Amdt. dated <u>July 20, 2007</u>

Reply to Office Action of <u>March 20, 2007</u>

## **REMARKS/ARGUMENTS**

10/732,804 Tae-Chee CHO et al.

FIG. 4

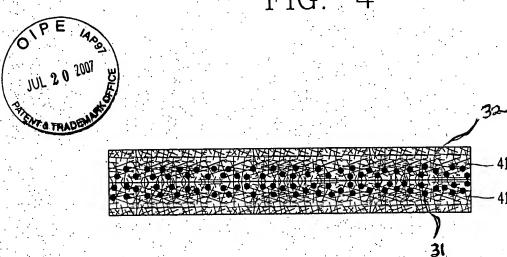
Amendments to the Drawings:

The attached drawings include changes to Figs. 4 and 6. These sheets, which include Figs.

4-7, replace the original sheets including Figs. 4-7. In Figure 4, previously omitted reference
